# Charlotte Department of Transportation

## Memorandum

**Subject:** Rezoning Petition 14-029: Approximately 1.6 acres located on the south side of Woodlawn Road between Old Woods Road and Fairbluff Place.

Figure 1

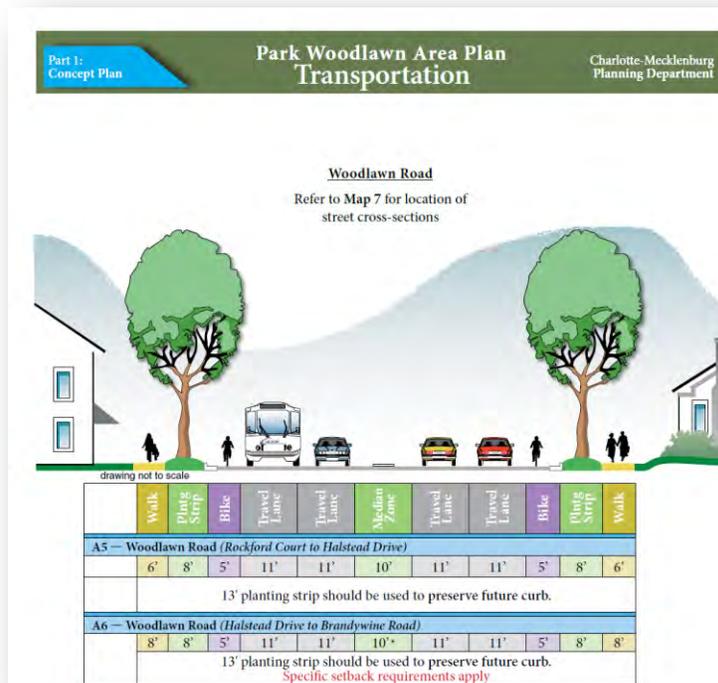
1. The Park Woodlawn Area Plan recommends a 13' planting strip and 6' sidewalk along the site's frontage on Woodlawn (Figure 1), along with a 10' center turn lane at major driveway locations. The current site plan shows an existing 4' sidewalk and 2' grassed strip. In order to accommodate the future turn lane, we request the petitioner provide an 18' planting strip off of the back of the existing curb.
